Attachment 1

Proposed Technical Specification Changes

Attachment 2

Discussion, No Significant Hazards Analysis and
Environmental Impact Statement

FIGURE 1

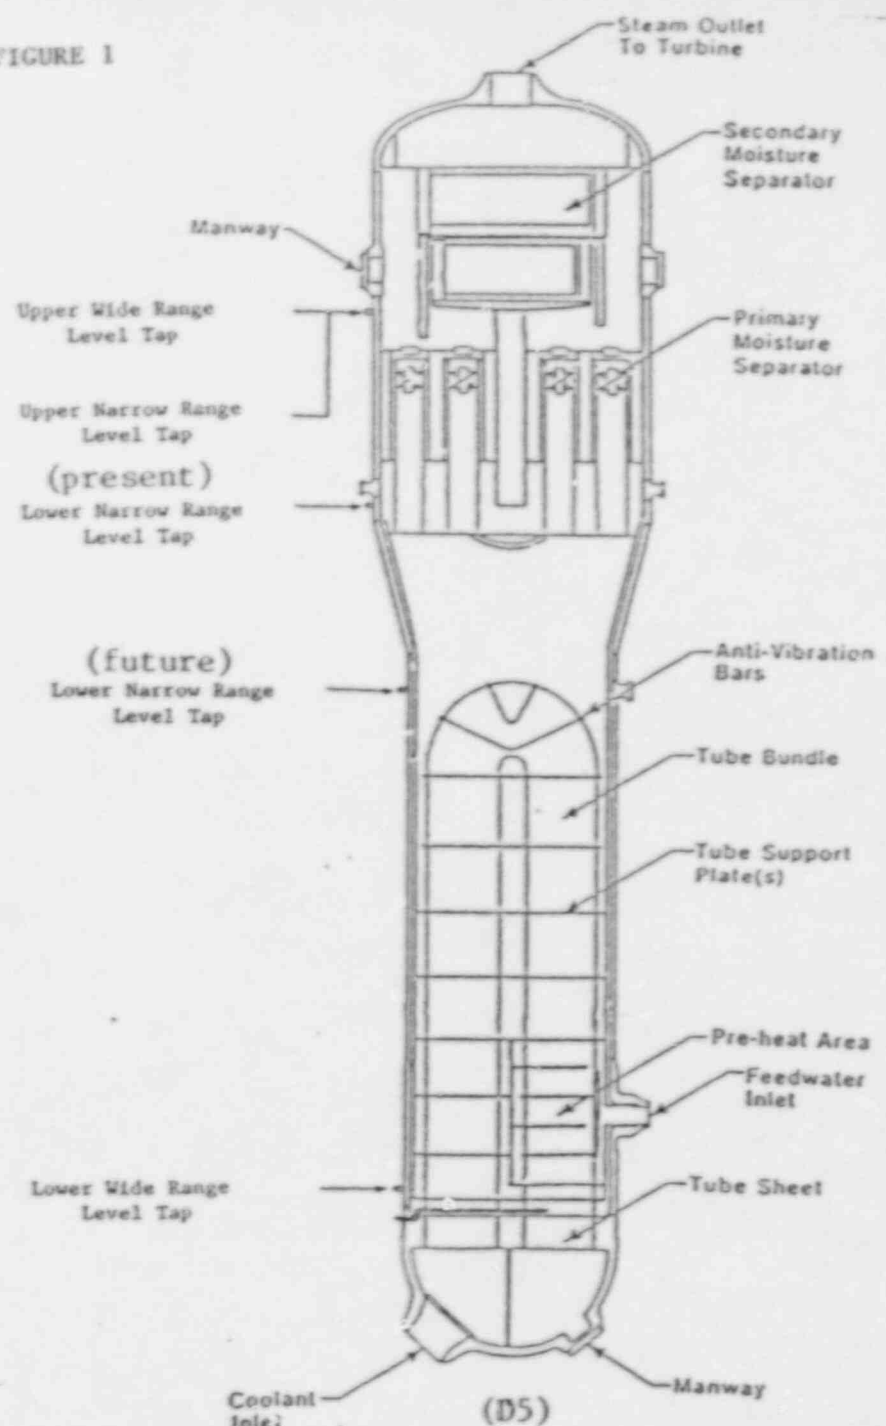
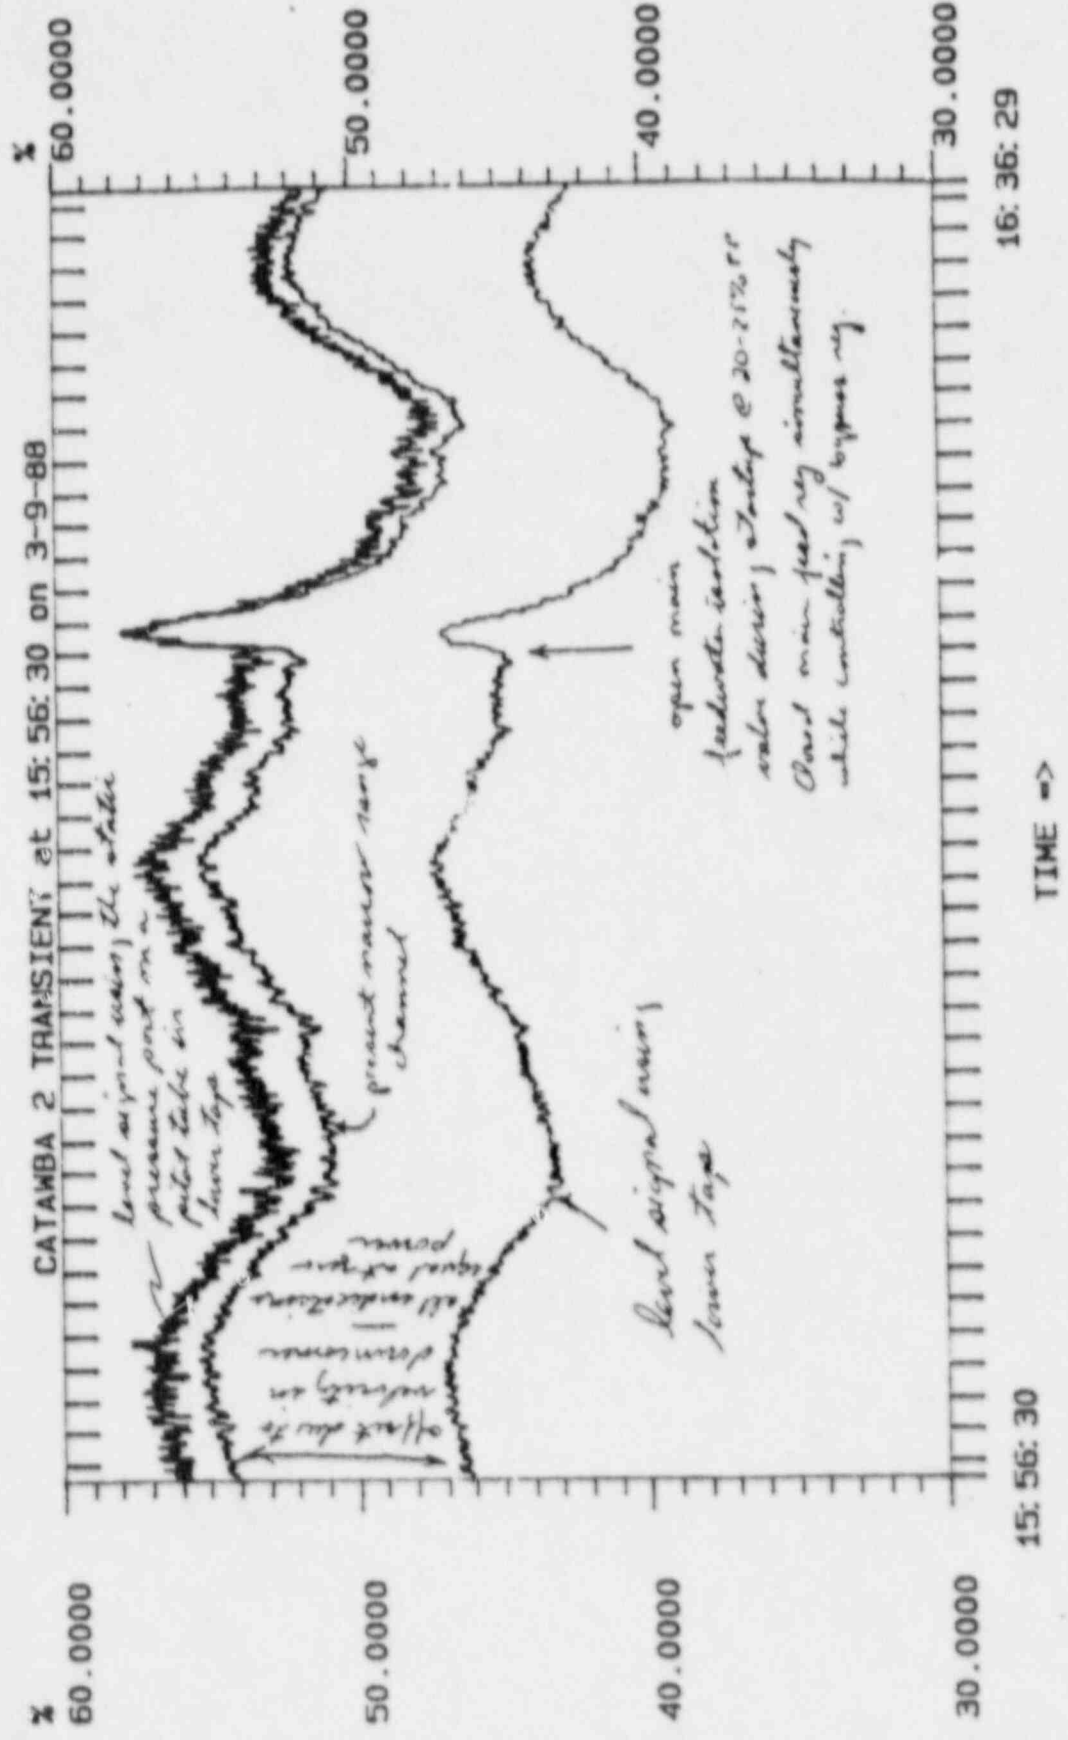
Catawba Units 1 and 2 are equipped with Westinghouse Model D3 and Model D5 steam generators, respectively. A major difference in these models is the design of the moisture separator section. Two aspects of this design difference are of significance with respect to the proposed modification: the D5 has a higher recirculation rate than the D3, and the elevation of the lower deck plate in the D5 is higher than in the D3. See Figure 1. Due to these differences the lower instrument tap for the narrow range level instrumentation was located above the transition cone and lower deck plate on the D5 as opposed to below the transition cone in the downcomer region on the D3. This has resulted in significantly different operating characteristics. The proposed modification will relocate the D5 lower instrument tap to the same location as the D3. The old level instrument taps will be capped.

(future)
Lower Narrow Range
Level Tap

FIGURE 2

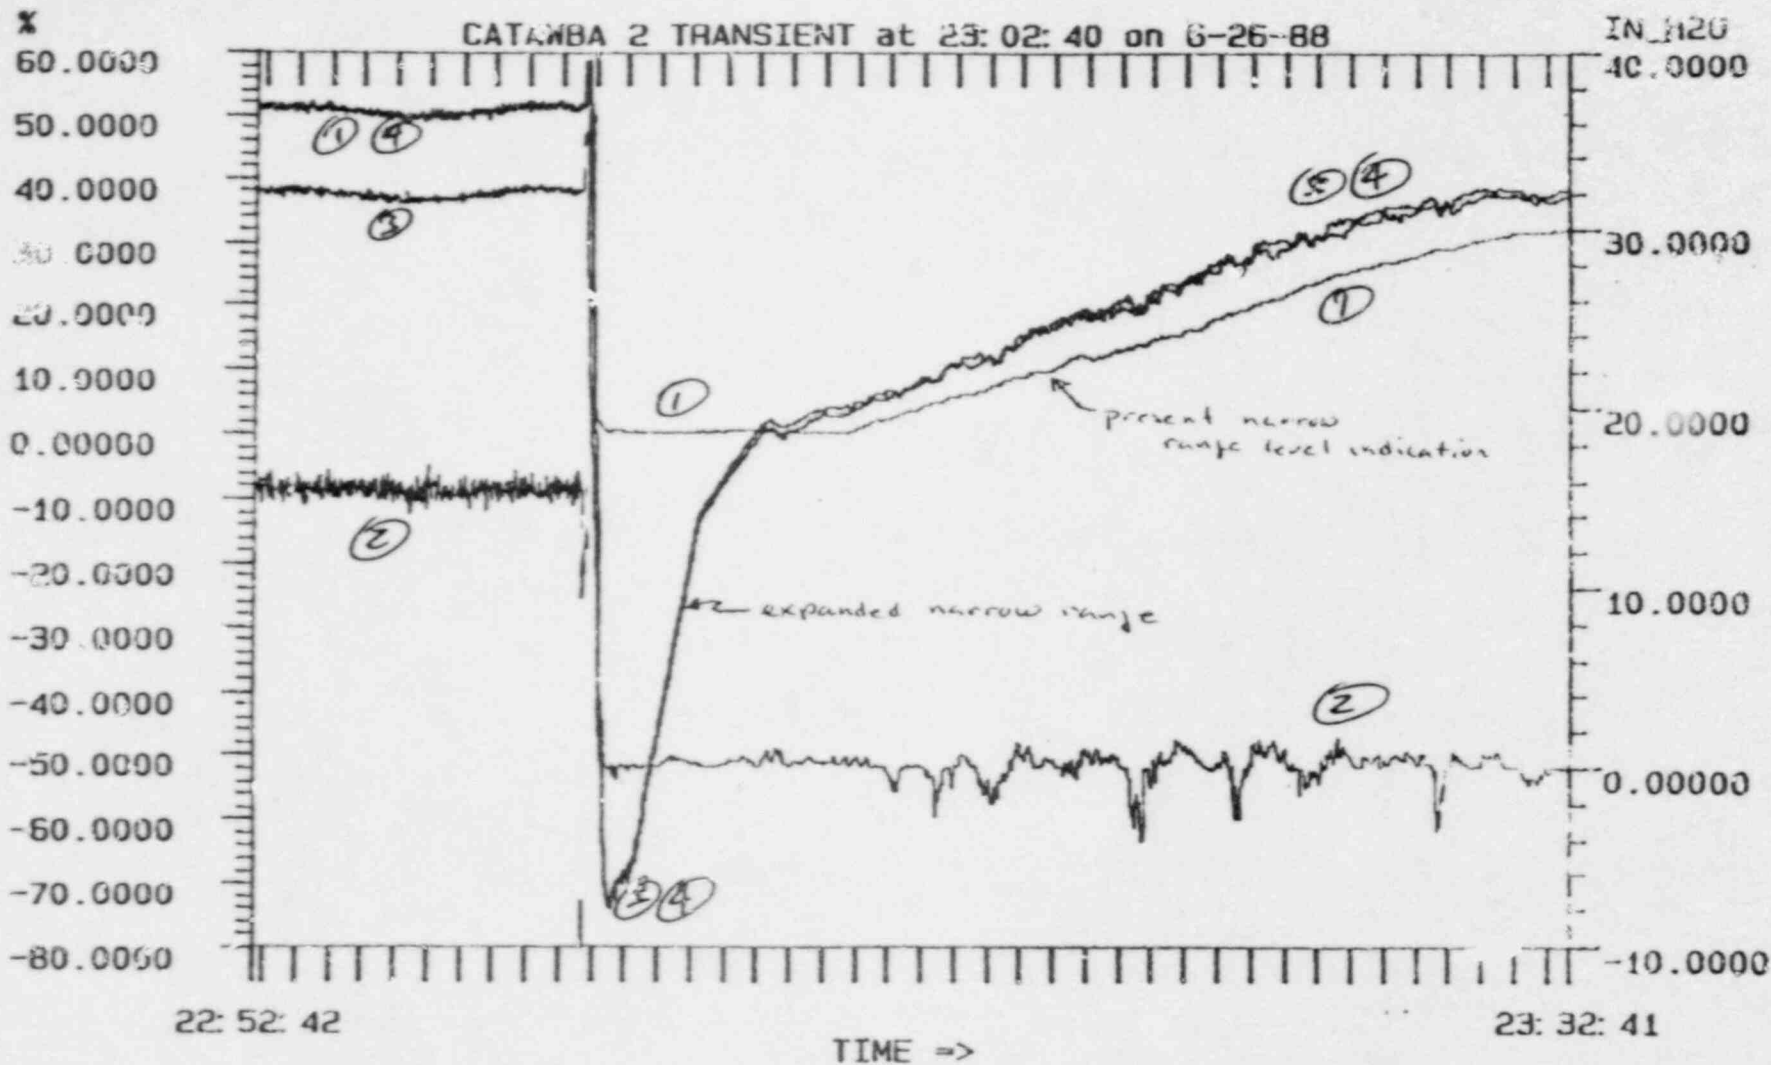
In order to determine the potential gain in operational control characteristics of the D5 steam generator if the lower instrument tap were relocated to the equivalent location as the D3, Duke and Westinghouse installed instrumentation on the Catawba 2C generator. One narrow range level channel was installed using the new lower tap location. A pitot tube was installed in another available location at the same elevation. The pitot tube static pressure connection was used to create another narrow range level channel which would be unaffected by the flow velocity in the downcomer. Transient data from these instruments and the currently installed narrow range level instrument clearly showed (1) that the shrink and swell is significantly reduced by the flow velocity feedback in the downcomer and (2) the indicated level when sensed in the downcomer and velocity compensated correlates extremely well with the current instrument configuration. See Figure 2.
